**KNOXVILLE HISTORIC ZONING COMMISSION
STAFF REPORT - CERTIFICATE OF APPROPRIATENESS APPLICATION**

PROPERTY ADDRESS: 1214 Luttrell St 37917

FILE NO.: 9-I-18-HZ

DISTRICT: Fourth and Gill H-1

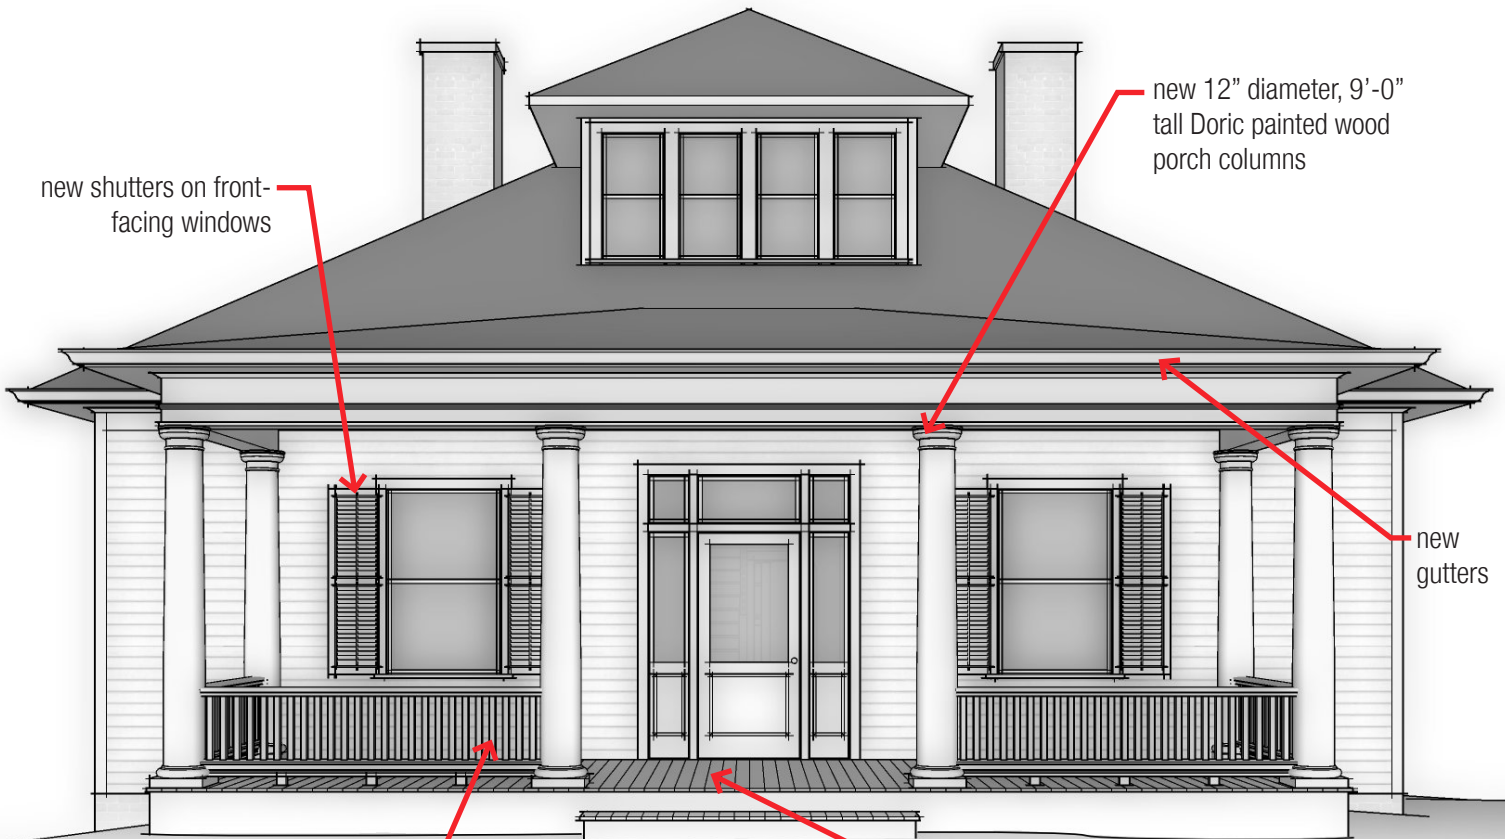
tuck point and repair north chimney

remove non-original columns, replacement shown below

replace ornamental door glass with clear lite; restore front door

remove door to upstairs apartment, patch siding in kind

new shutters on front-facing windows

new 12" diameter, 9'-0" tall Doric painted wood porch columns

Staff recommends approval with the condition that the shutters not be installed, and that the balustrade top rail be a molded design in order to be compatible with the round porch columns.

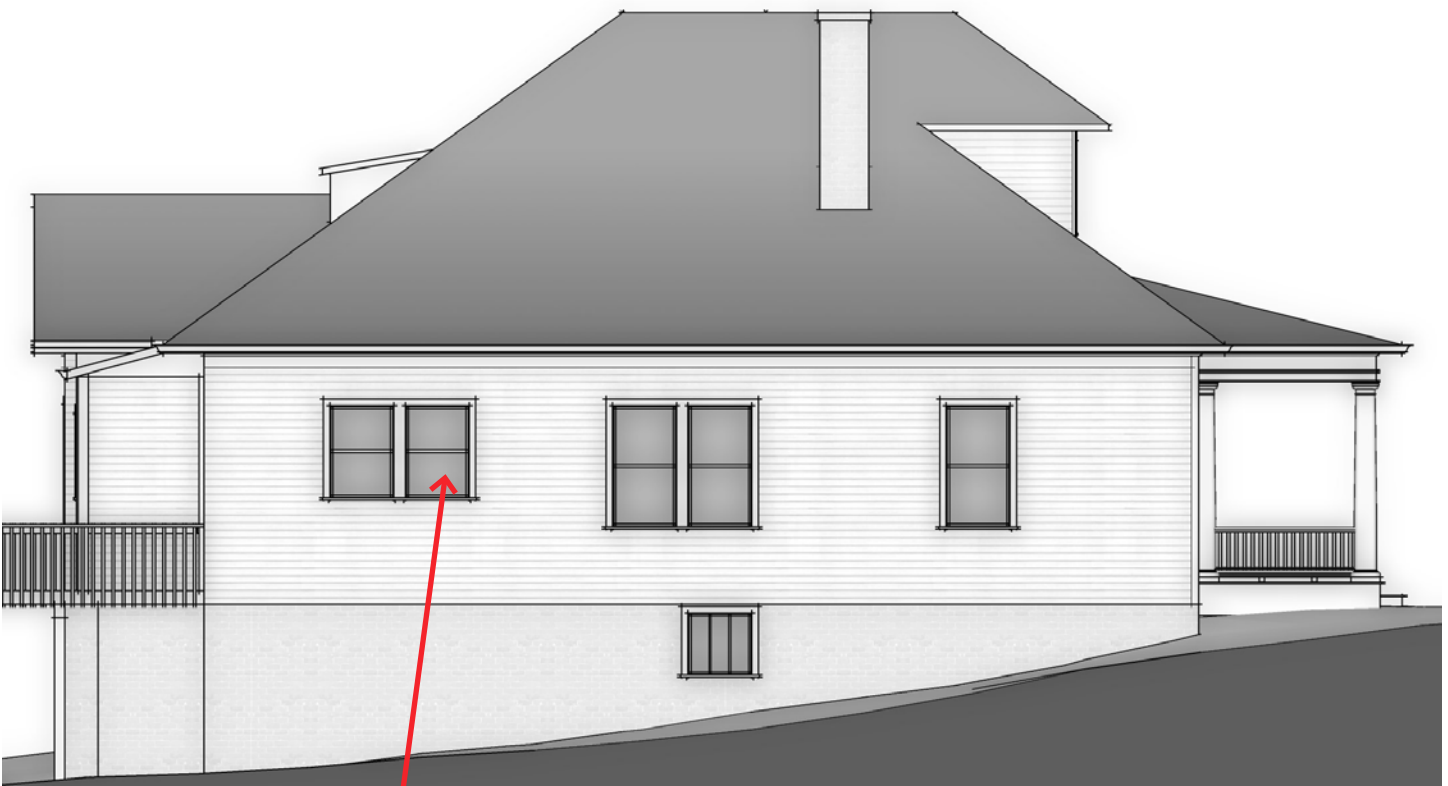
new gutters

new 30" tall handrail with 1.5" square balusters spaced 4" on center

new stained wood porch floor

patch line in siding shows location of original double window to be restored

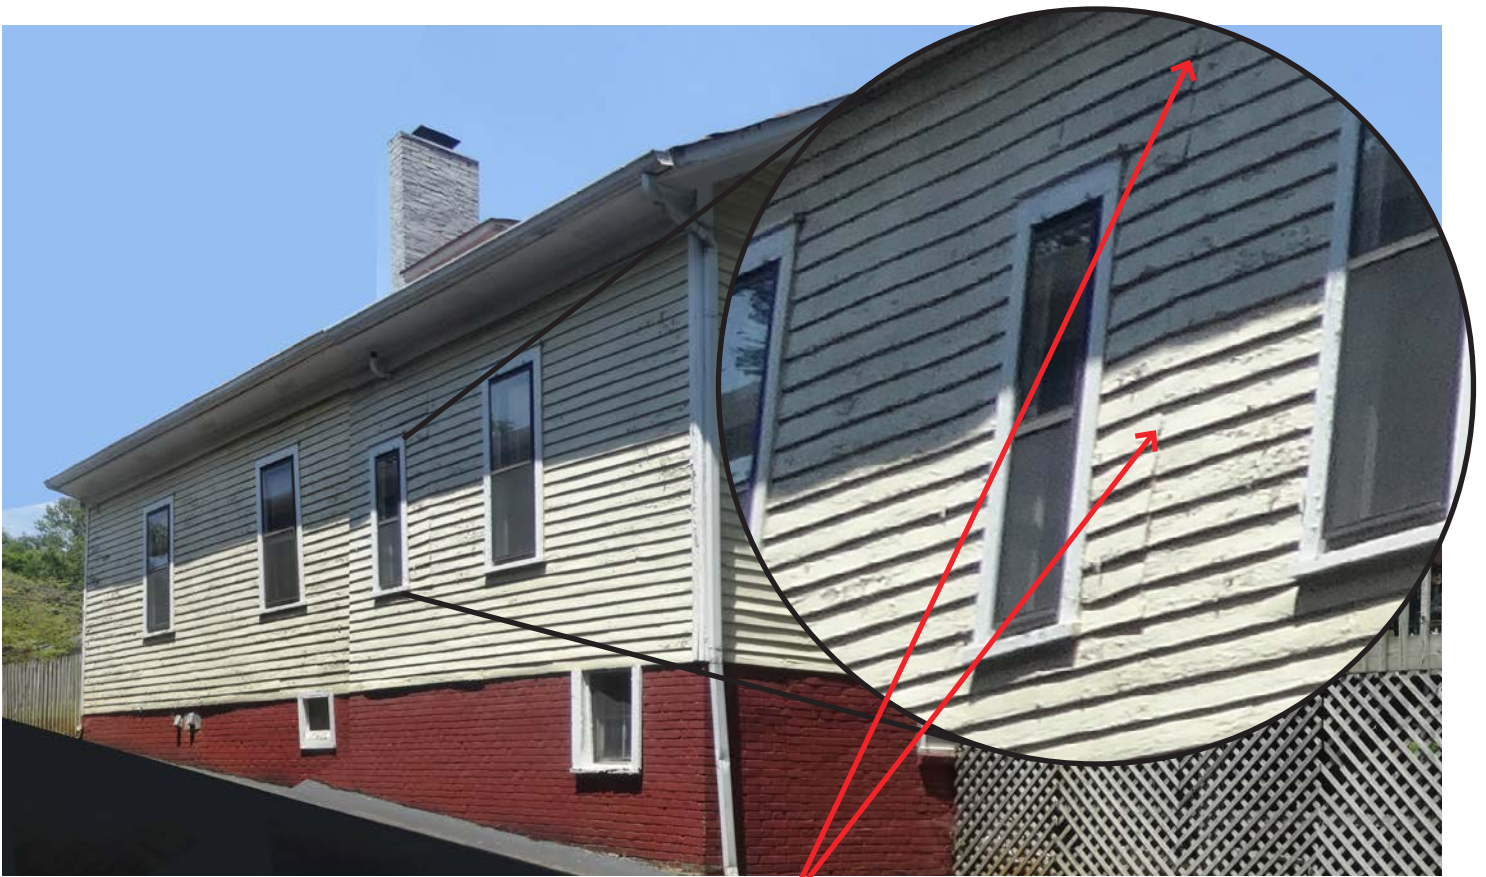
replacement double window to be 1-over-1 double hung, wood inside and out. size and profile to match existing.

3) There is evidence in the siding that small windows on the side were reduced from larger windows matching others on the façade; therefore, replacement of these windows with historically-sized wooden windows is appropriate.

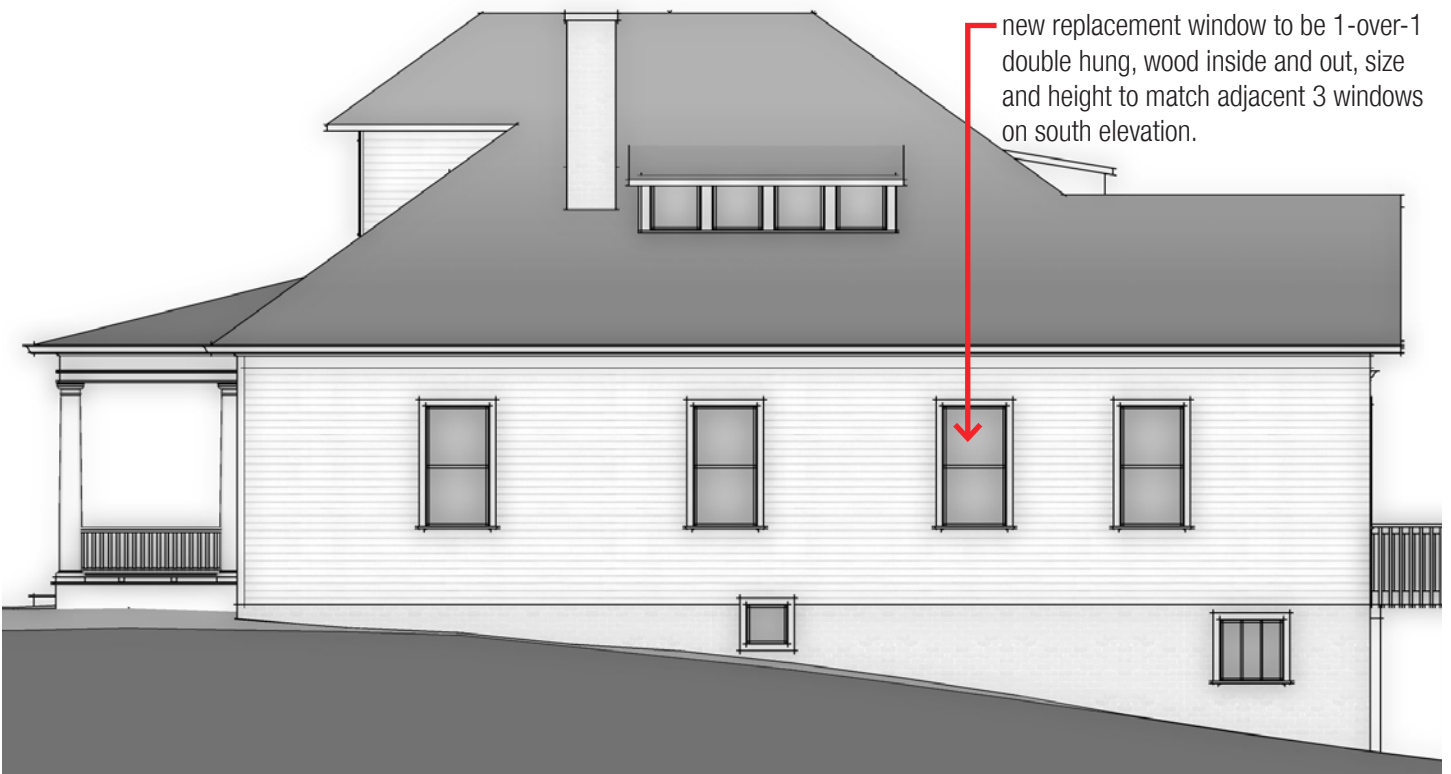
patch line in siding shows size of original window to be restored

new replacement window to be 1-over-1 double hung, wood inside and out, size and height to match adjacent 3 windows on south elevation.
